SIB 28 02 24

SERVICE ACTION: DOUBLE CLUTCH TRANSMISSION REWORK AT TRANSFER CASE

2024-12-20

This Service Information Bulletin (Revision 4) replaces SI B28 02 24 **dated August 2024**.

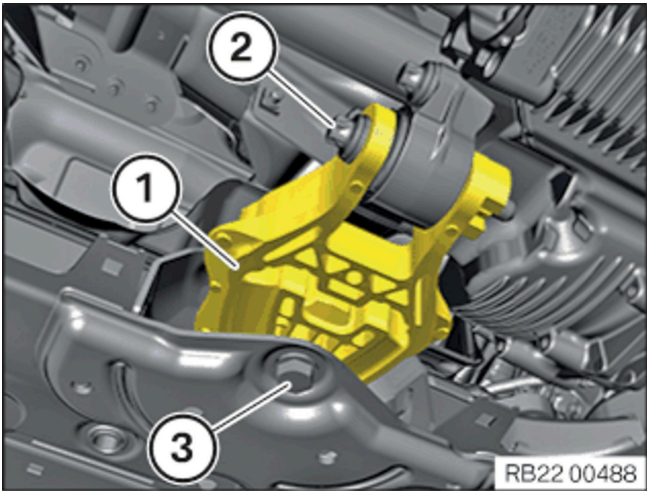
Micro-movements combined with frictional corrosion can increase wear on the longitudinal splined connection between the double clutch transmission (DCT) and the transfer box.

Add spacers at the connection between the DCT and transfer box to decrease micro-movements.

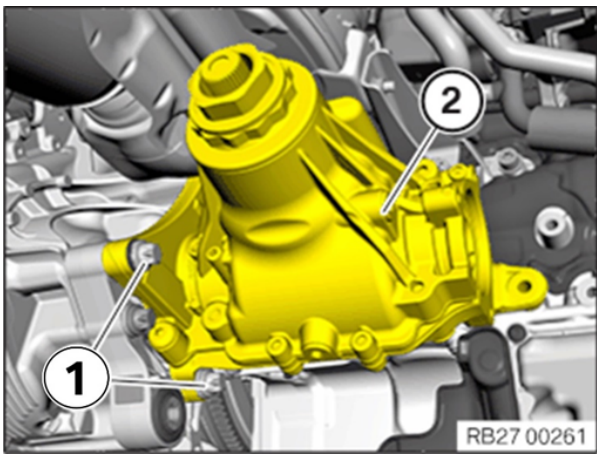
Remove the stabilizer link (1).

Reinstallation: Replace bolts 2 and 3

Tighten to 100 Nm and torque angle 90°

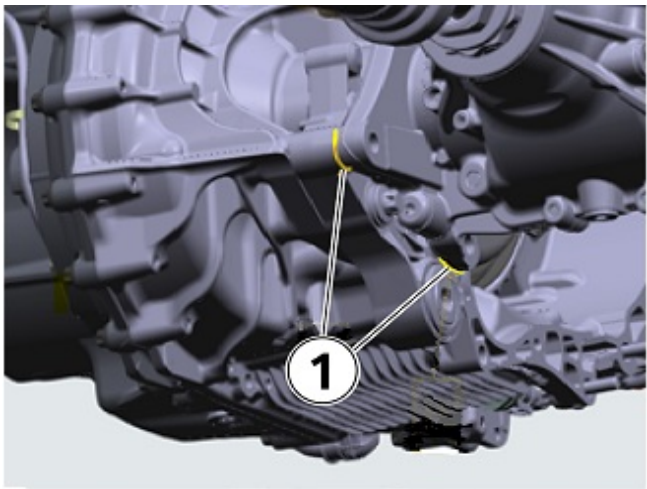
Remove the two bolts (1) on the transfer case.

Reinstallation: Replace both bolts

Tighten to 100 Nm and torque angle 90°

Install washers between the link and transfer case. It may be necessary to slightly push the transfer case to the side to install the washers.
